Bid Addendum 02

Project: CATA Renovation at 511 S Washington Ave, Lansing, MI 48933

Project No: 75820023

DEMOLITION NOTES AND LEGEND

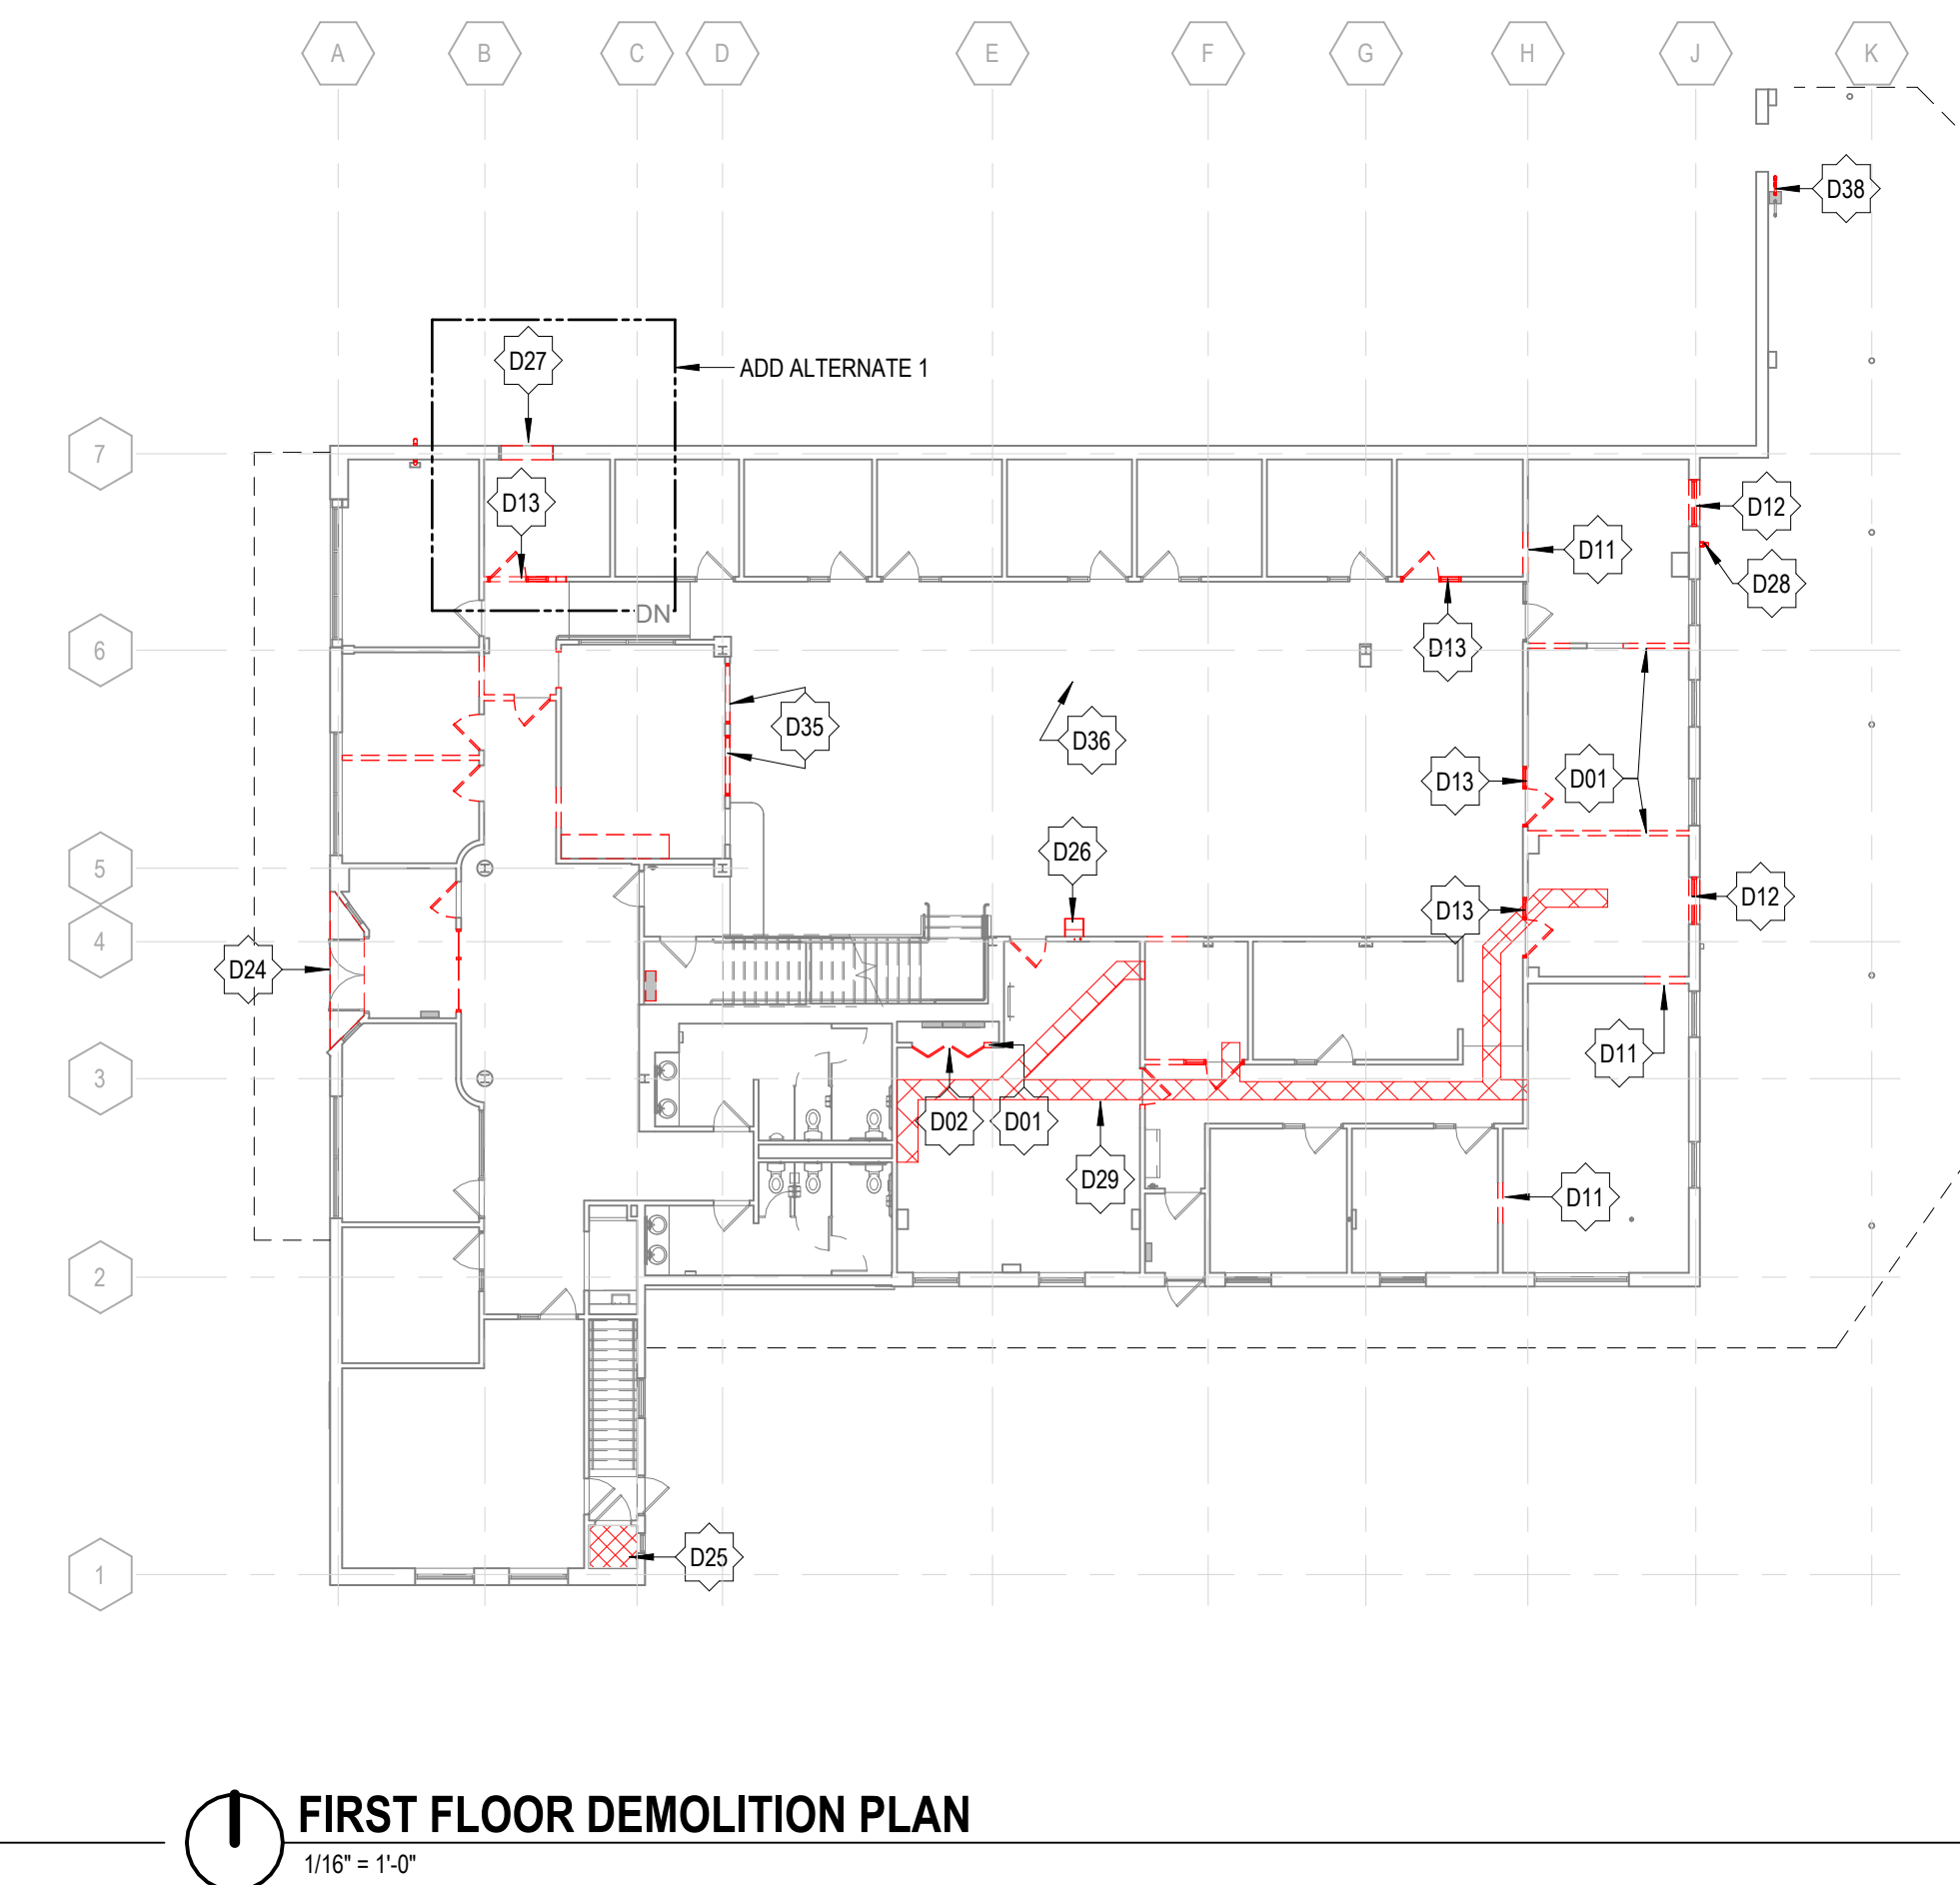
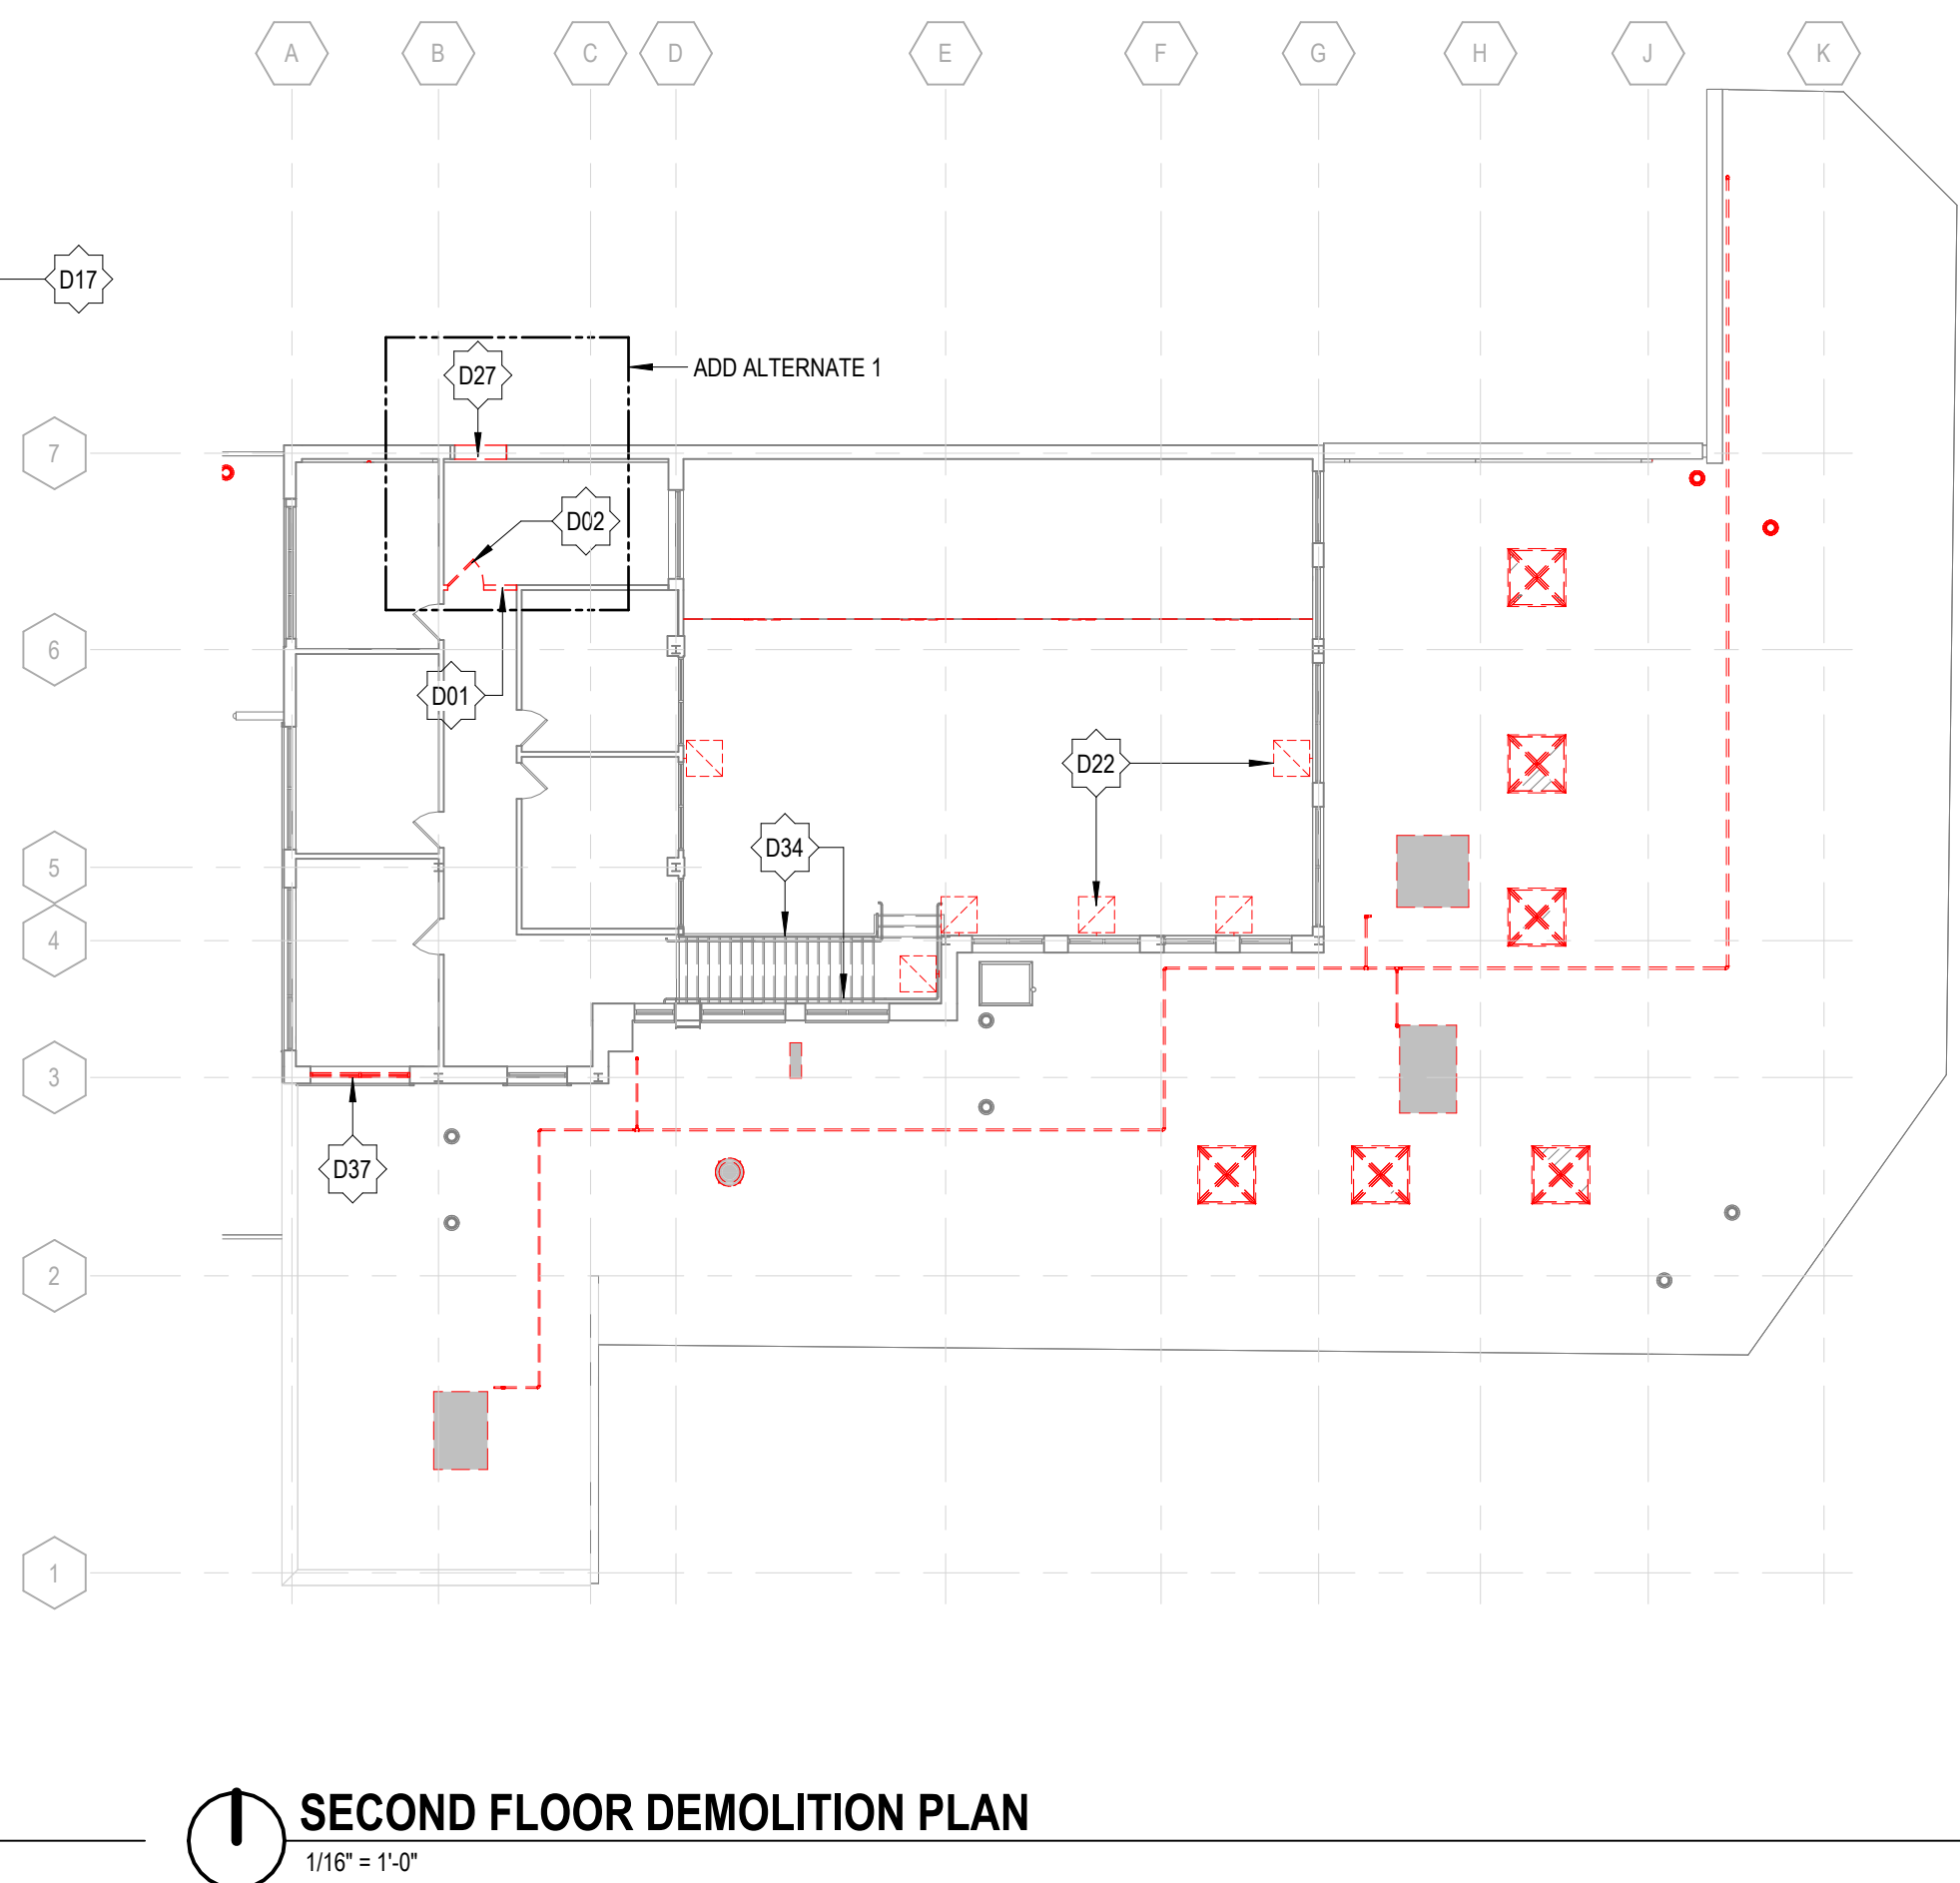
- 1. **Drawing AD101** (Reissued): Add basement demo floor plan to show doors being demolished in basement.
- 2. **Drawing A101** (Reissued): Update basement floor plan doors to show correctly as new with tags. Remove Keynote A18 "REPLACE ALL OPENINGS WITH HOLLOW METAL DOORS AND FRAMES. PROVIDE NEW DOOR HARDWARE."
- 3. **Drawing A104** (Reissued): Update roof plan to add ¼" slope to upper roof for positive drainage required.
- 4. **Drawing A601** (Reissued):
 - a. Update Door Schedule to include basement doors.
 - b. Update door hardware and comments information.
 - c. Update aluminum doors 119A, 119B, and 105A from 4" head to 7'-2" door with standard head to fit masonry opening.
- 5. **Drawing A602** (New Issue): Add Door Hardware Schedule sheet.
